DEVIATION REQUEST AND DECISION FORM

Project Name :	Solace Apartments
Schedule No.(s) :	5407200052
Legal Description :	THAT PORTION OF SECTION 7, TOWNSHIP 14 SOUTH, RANGE 65 WEST OF THE 6 TH P.M., EL PASO COUNTY, COLORADO, DESCRIBED IN BOOK 5046 AT PAGE 748; AND POWERS AND GALLEY PLAZA FILING NO. 1 AS RECORDED IN PLAT BOOK 1-4 AT PAGE 30 OF THE RECORDS OF SAID COUNTY.

A deviation from the standards of or in Section **2.2.4.B.4 for Roadway Cross Sections** of the Engineering Criteria Manual (ECM) is requested.

Deviation Report for Paonia Street_V2.pdf Markup Summary

Figure 2-14. Typical Urban Nonresidential Collector Cross Section

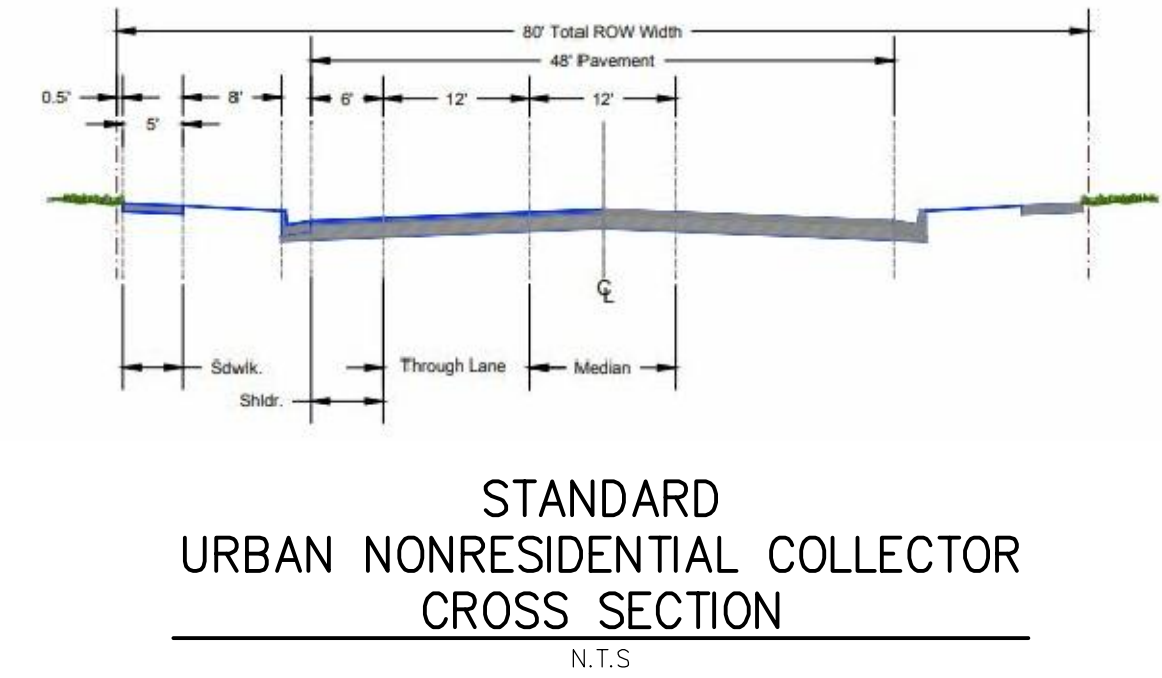
The standard cross section indicates an 8 ft. area.
The 14' is what your proposed section has due to the reduced pavement section. Please revise.

The standard cross section indicates an 8 ft. area. The 14' is what your proposed section has due to the reduced pavement section. Please revise.
